**PAT-1 Safety Analysis Report Addendum
Author Responses to
Request for Additional Information**

Docket No. 71-0361

**Reference: Letter Eric Brenner, U.S. NRC to Maximo Barela, U.S.
DOE-NNSA, dated March 1, 2010**

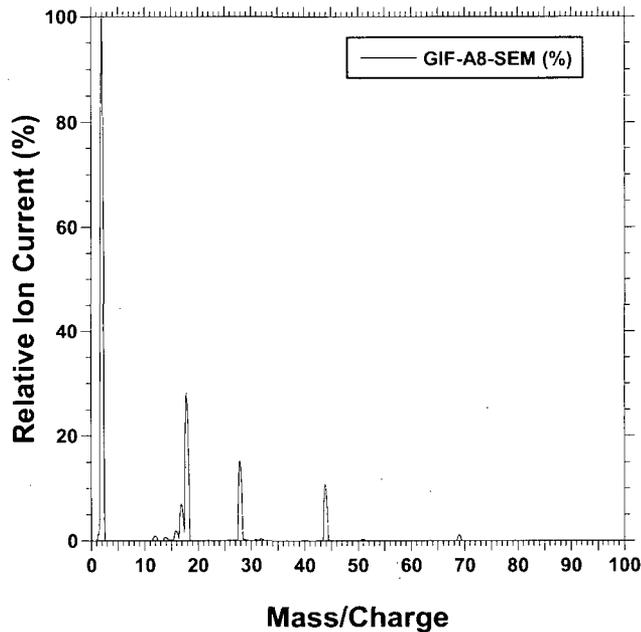
Place restrictions on the operating time of the package to prevent radiation damage to the elastomer seals in the package, and/or change the elastomeric seal materials. Clarify the radiation dose received by the elastomer seal on the TB-1.

The ORNL predicted doses for gamma (2.8×10^4 rad/year) and neutron (3.4×10^4 rem/year) radiation based on a realistic source are less than the 10^5 rad cited for no effect in the DuPont technical bulletin and are only marginally above 10^4 rad (cited in Bouquet, 3rd edition, 1990, (Ref. 1), treating neutrons and gammas equally and exposing for a full year. Note that the 3rd edition Bouquet reference only cites "fluorocarbons" and does not provide further details regarding manufacturers' data. In a 1985 article by Bouquet (Ref. 3), he shows in *Figure 4 Summary of Radiation Data for Elastomers. Property: Tensile Strength. Above Average Response Level* that the lowest threshold damage for Viton A® starts at about 6×10^6 rads and the 25% change dose is at about 6×10^7 rads. In *Figure 6 Summary of Radiation Data for Elastomers. Property: Elongation.*

Average Response Level for Viton A, the lowest threshold dose starts at about 10^7 rads and the 25% change dose is slightly above 10^7 rads. Thus this conservative dose estimate of about 5×10^4 rads from the ORNL analysis places the seals under the "little or no effect" dose range for Viton® seals with a full year of contact according to DuPont (also conservative since most shipments should be completed within a month) and at least an order of magnitude below the threshold damage level data for tensile strength and elongation from the Bouquet 1985 article. Furthermore, the amount of time the seals would be typically in close proximity to the contents would make these estimates even closer to a 1×10^4 rad cumulative dose for one year.

In conclusion, there is no need to place restrictions for the one year operating time of the package to prevent radiation damage to the elastomer seals because the Viton® A elastomer seals would experience no loss or minor loss in mechanical properties from radiation from the plutonium metal during NCT. Furthermore, the Viton® A elastomer seals in the T-Ampoule and SC-1 and SC-2 sample containers are not containment boundary components and do not provide a safety function but serve to maintain product quality.

Request for Additional Information: 2-8

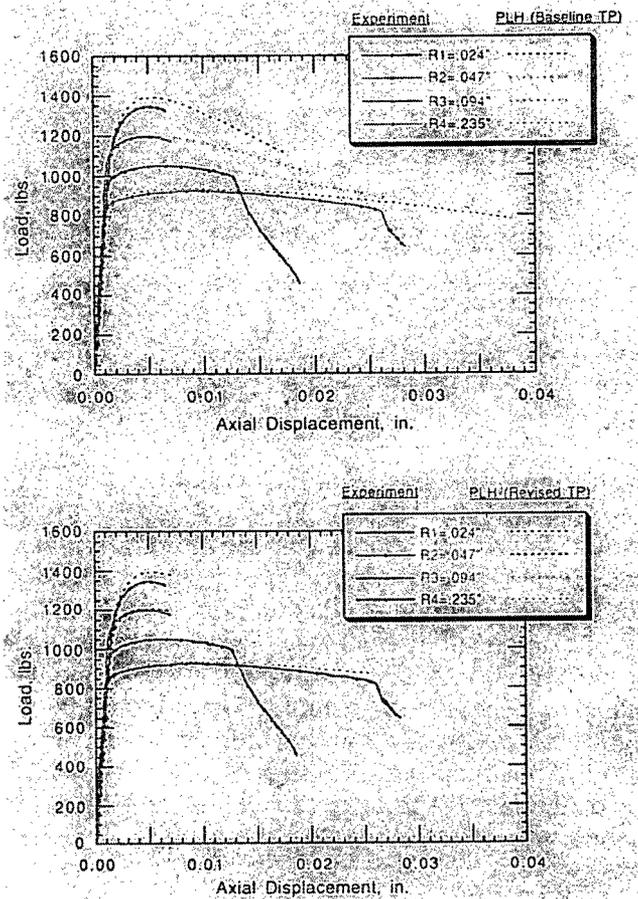
Describe in detail how the critical tearing parameter is determined and its relationship to the locus in equivalent plastic strain – stress triaxiality space.

The applicant derived the critical tearing parameter based on a finite element simulation of a uniaxial tension test. Given the multiple references to stress triaxiality, staff is unclear whether the formulation and use of a 1D acceptance criterion in conjunction with a 3D stress strain state locus is a consistent and relevant methodology.

First, this isn't a 1D acceptance criterion at all; it has been proven to work exceedingly well for many 3D stress states (in fact the addition of the 4th power over Brozzo's similar original failure criterion in 1975 was to better match highly notched, highly 3D specimens. See the figure below, where the upper graph compares notched tensile tests with FEA using the Brozzo failure criterion, and the lower graph shows a much better match using the updated Tearing Parameter (TP) [reference: Dawson, D. B., Antoun, B. R., and Mosher, D. A., "Fracture of Weapons Materials," Memo report to distribution, page 18, October 5, 1998, Sandia National Laboratories]). Even the uniaxial tension test used to determine the critical TP value is actually a 3D stress state (or at least 2D axisymmetric) due to the necking that occurs up to failure.

The TP equation needs to be slightly modified in SAR; (see below). The TP almost appears to have stress triaxiality within its definition because it (the integral) only accumulates value when the ratio inside the Heaviside brackets (tends to mimic stress triaxiality) is positive, but it also accumulates value (damage) much more quickly when the Heaviside ratio (mimicking stress triaxiality) is highly positive, as in near-perfect hydrostatic tension. But stress triaxiality is the mean stress (average of 3 principal stresses) divided by the von Mises stress, whereas TP has the difference of the maximum principal stress and the mean stress in the denominator.

Changed the text in Section 2.12.3.2 and Section 2.12.3.6. In Section 2.12.3.3, moved Figure 2-52 from Section 2.12.3.6 to 2.12.3.5. Section 2.12.3.8, and the third-to-last reference in Section 2.12.3.9 were changed in the SAR Addendum in response to this RAI and RAI 2-6.

Request for Additional Information: 2-9

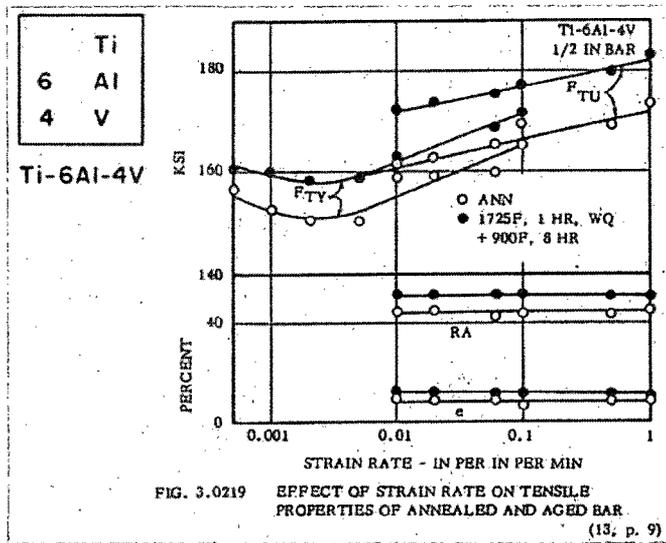
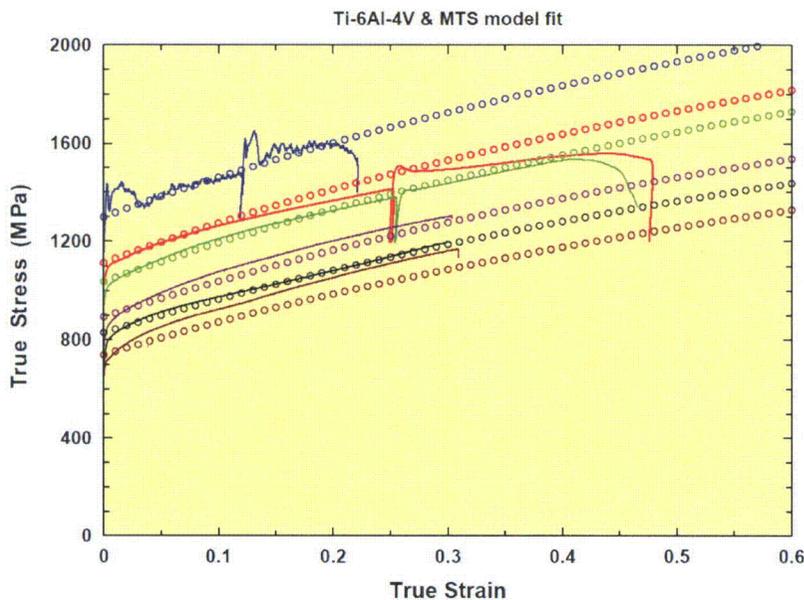
Demonstrate that the locus in equivalent plastic strain – stress triaxiality space is not strain rate dependent.

Given that this locus was developed at speeds of 200 ft/s rather than 422 ft/s, the applicant should provide a velocity range for which the locus is applicable. Alternatively, the applicant should provide a thorough explanation as to why the locus developed at lower velocity is acceptable to use outside of the regulatory framework requiring a velocity of 422 ft/s.

Some materials have high strain rate dependencies, but Ti-6Al-4V was chosen for the T-Ampoule eutectic barrier material due not only to its high strength, light weight, good ductility, and excellent corrosion resistance, but also because of its low strain rate sensitivity. For example, the material is commonly used in the aerospace industry for jet engine fan blades, in part because of its resistance to failure during bird strikes. At lower strain rates (0 to 1 inverse seconds), the yield and ultimate stresses harden slightly, but ductility is unaffected (reference graph from: "Department of Defense Aerospace Structural Metals Handbook", code 3707, page 12, March 1965), as shown below.

Los Alamos National Laboratories compiled historical data on higher strain rate testing of Ti-6Al-4V (Reference: Strain Rate Sensitivity Data Used in LANL's Ti-6Al-4V MTS Strength Model, e-mail from George T. Gray (Los Alamos National Labs) to David C. Harding (Sandia National Laboratories), February 19, 2010) and it shows only relatively modest increases in strength and decreases in ductility (especially relative to other

ductile metals, which are typically much more strain rate sensitive) up to 1340 /sec strain rates (see graph below, the solid curves).

A new section, 2.12.3.7, Strain Rate Dependencies, was added to the SAR Addendum in response to this RAI.
